STAFF RECOMMENDATION 1612 Sumner Avenue September 20, 2017

Application: New construction – addition
District: Eastwood Neighborhood Conservation Zoning Overlay
Council District: 06
Map and Parcel Number: 08306006800
Applicant: Erwin Latimer and Barbara Harper Latimer
Project Lead: Sean Alexander, sean.alexander@nashville.gov

Description of Project: The applicant proposes to construct a ridge raise and rear addition, with a portion taller than the original building with dormers stepped in two feet (2') from the original side walls

FIRST FLOOR DEMO

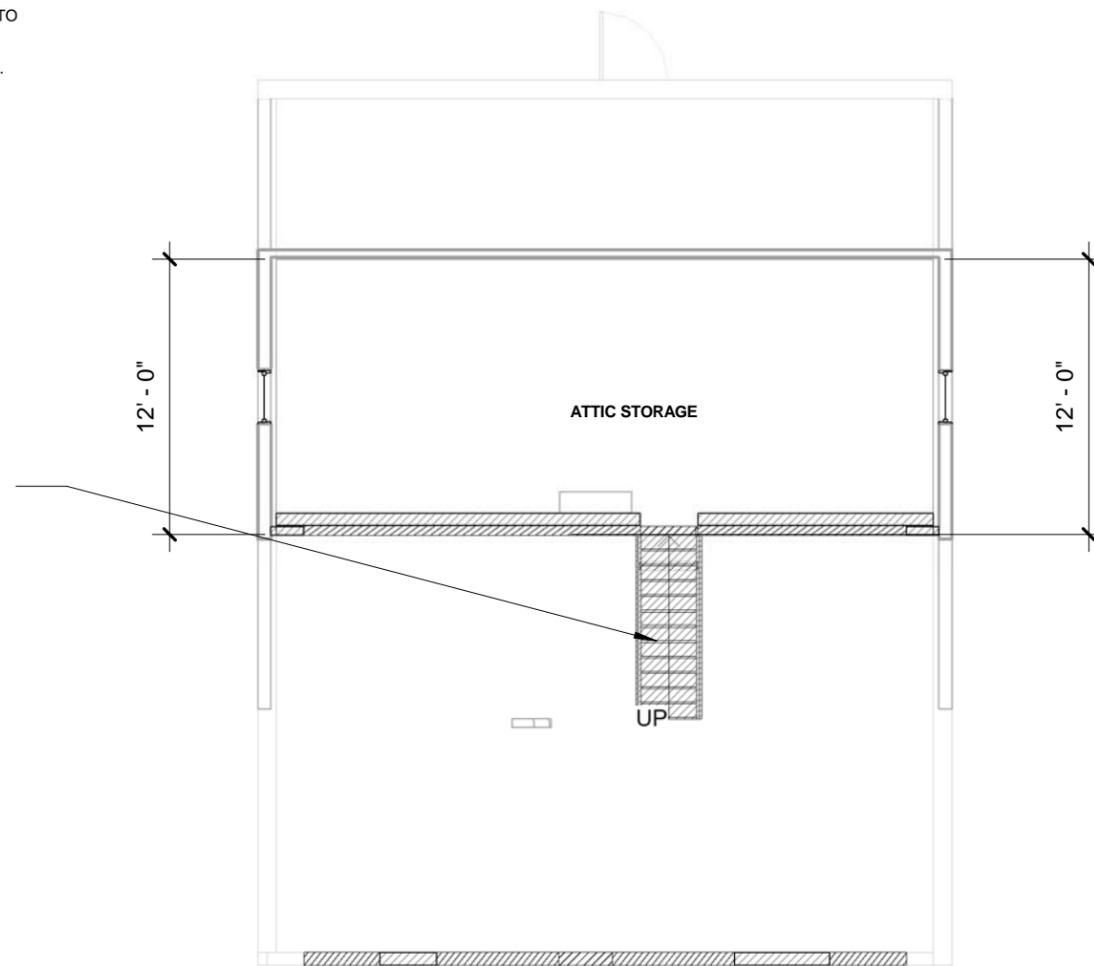
Demolition: In the course of constructing the proposed additions, the majority of the rear slope and the pair of rear-facing gables will be demolished. These portions of the building cannot be seen from the right of way, therefore they do not contribute to the appearance or significance of the house. The plans also show an existing double-hung window in the center of the right façade will be shortened to half of its current size, and two windows toward the rear of the left façade will be shortened to roughly three-fourths of their current size. Altering window sizes is not generally appropriate, however because these openings will remain in the current locations and they are at or beyond the midpoint of the main mass of the building, Staff finds that the overall impact on the appearance of the house will be relatively minor. Therefore, Staff finds that the partial demolition of these elements meets Section III.B.2 for appropriate demolition and does not meet section III.B.1 for inappropriate demolition.

ROOF PLAN

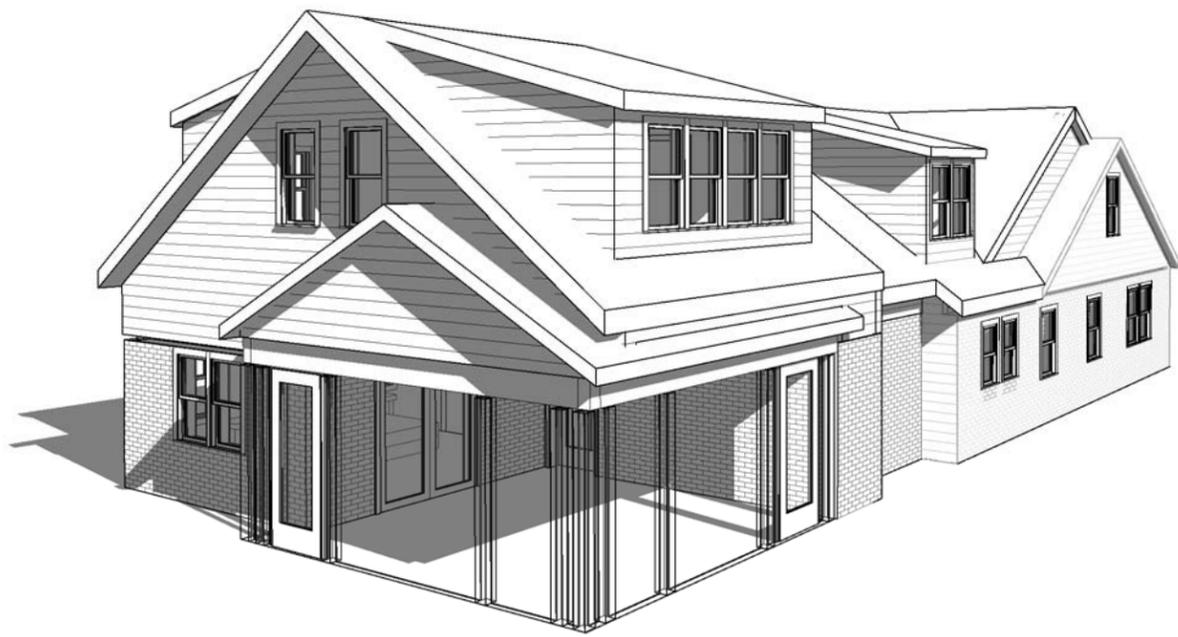
Roof form: The new roof of the addition will be stepped gables with a pitch of 8.5:12, which will not contrast with the 7.5:12 pitch of the original roof. A shed-roofed dormer with a 3:12 pitch will be on each side slope of the main roof on the addition and there will be a small section of roof with a 6.5:12 pitch at the very rear. The dormers will be stepped back two feet (2') from the first story walls below as is typical of dormers historically. Staff finds that the roofs of the proposed addition are appropriate and that the project meets section II.B.1.e of the design guidelines.
